8900 SYSTEM SCHEDULE

In response to your verbal request for changes in the specifications of the Mattel product (8900 System), we have analyzed the new design requirements, and listed below is a summary of the impact of these changes:

MATTEL VIDEO GAME SYSTEM MEMORY MAP

This will document Mattel's requests for changes to the specifications for the Mattel video system as originally defined in Exhibit B of the Development Agreement dated June 29, 1978. The requested changes are as follows:

* DESIGNATES PARTS TO BE OBTAINED BY
SYLVANIA FOR FIRST 50 SYSTEMS
MATTTEL VIDEO GAME SYSTEM

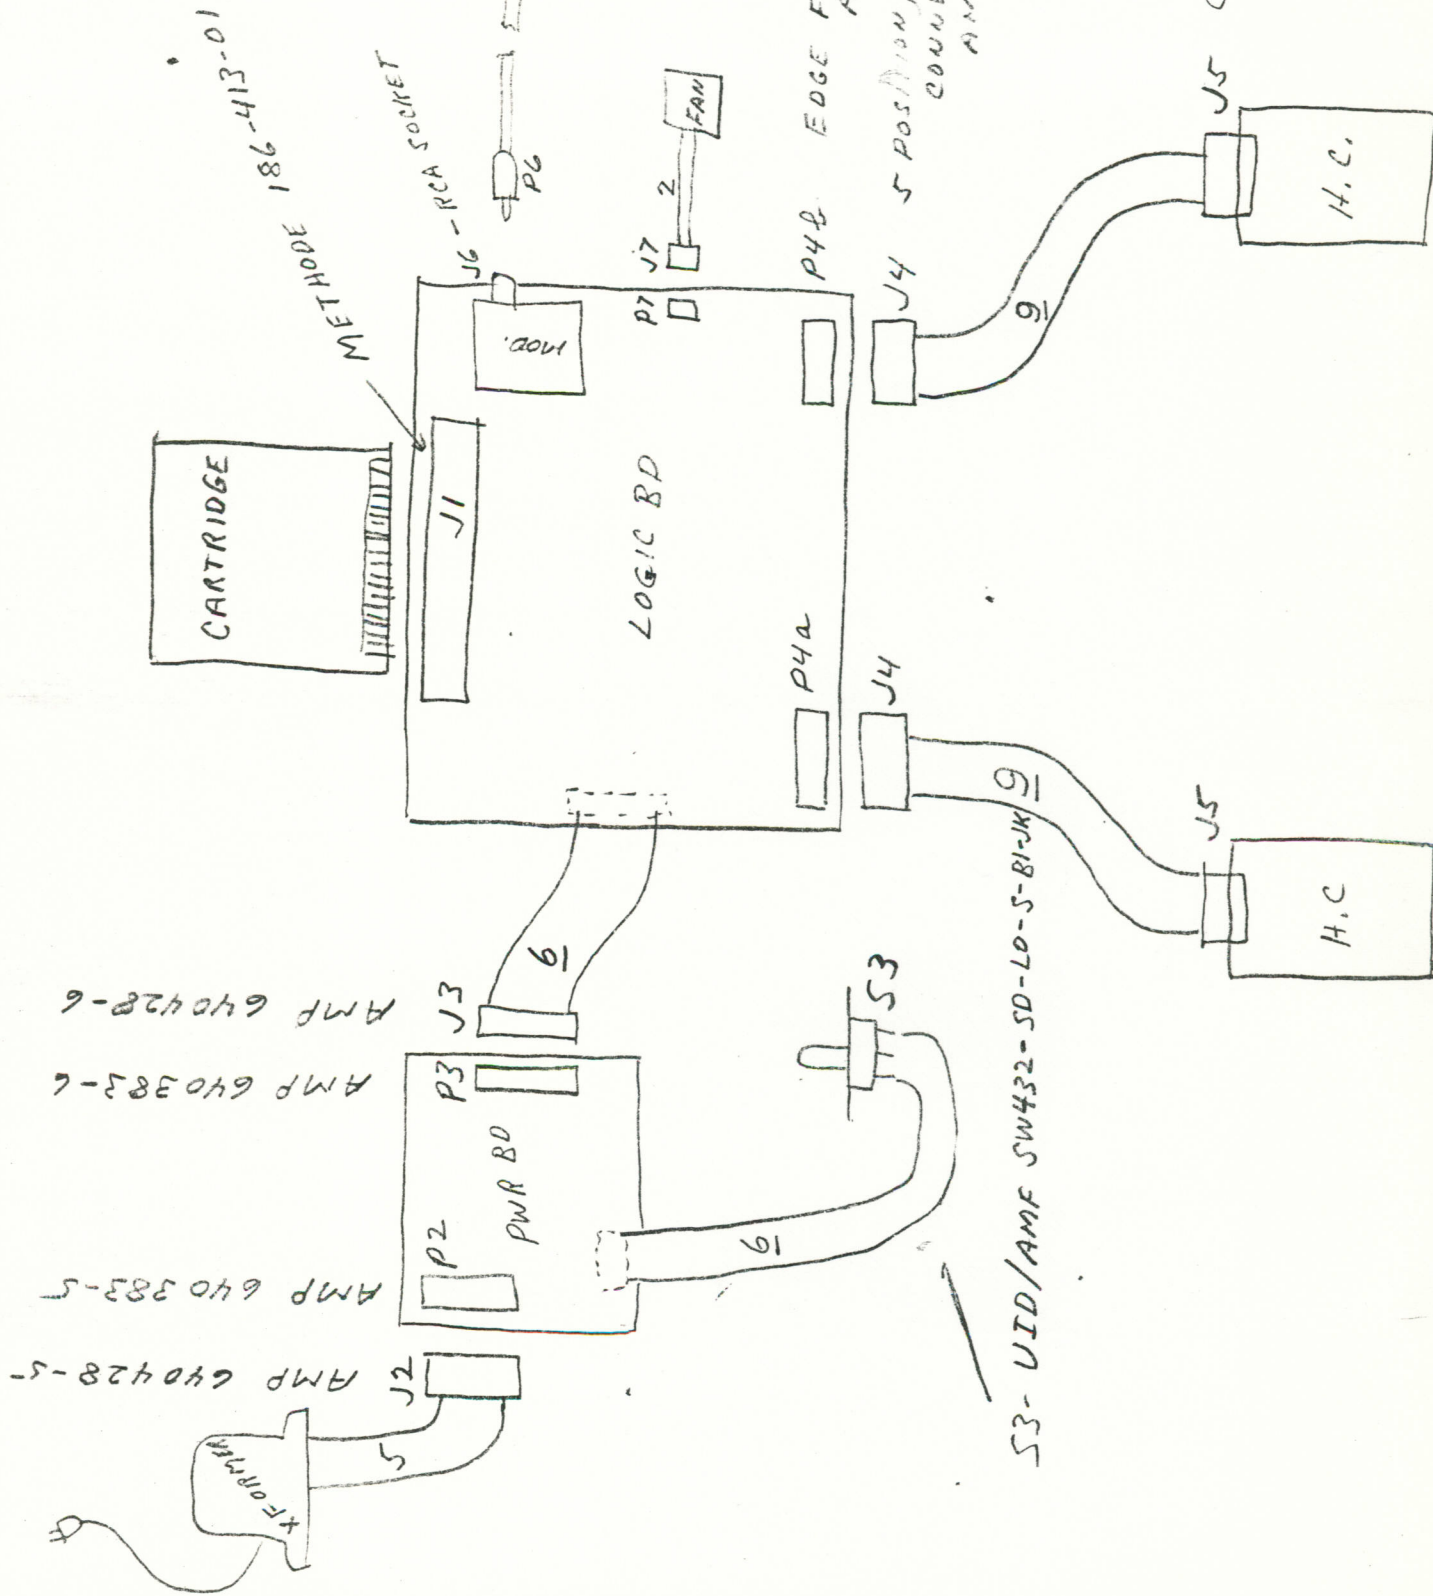
Enclosed is a copy of your most recent parts list marked up to reflect parts Sylvania is to obtain for the first 50 systems. Attached to this list is a sketch showing the interconnections with plug and jack designations. This sketch should serve as a working tool until such time as a formal drawing gets generated.

Also enclosed is a spec sheet on the CTS cricket switch proposed for the reset switch.
